3070-96B

# Modification Available Performance Enhancement Service Note

## Keysight i3070 Series 5 Inline In-Circuit Test System

**The Problem** – Remove unused secondary Press of Inline ICT

Figure 1: Runner Block and Rubber support hard-stop.

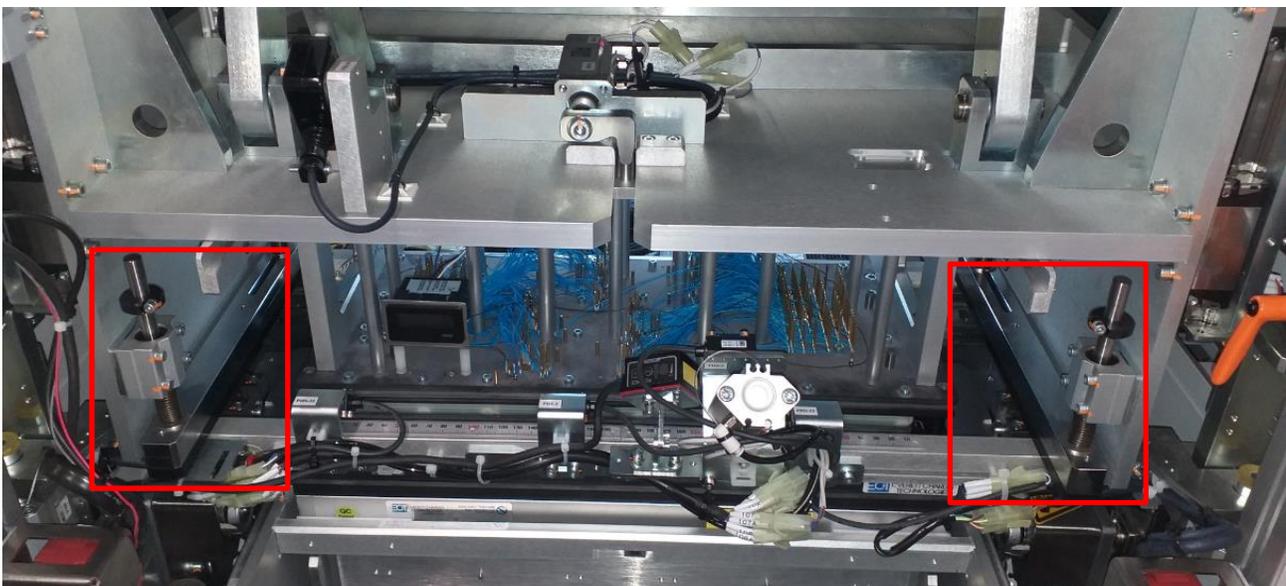
During the inline automation press and test cycle, the conveyor rails should sit flush on the bottom fixture after the rails move to the down position. In this position, the conveyor rails runner block will not reach the rubber support hard stop (Figure 1) regardless of the bottom fixture profile used.

When the Press moves to “All probe” position, the secondary Press (Figure 2) will have some force acting upon the rails. There is a perception that this force may cause significant impact to the conveyor rails over the longer term.

The secondary press is no longer installed in E9988EL and E9986E systems since June 2019 as it does not serve any functionality. It is therefore advised that the secondary press is removed on existing installed systems.

The PLC firmware should be updated to the latest version following removal of the secondary press.
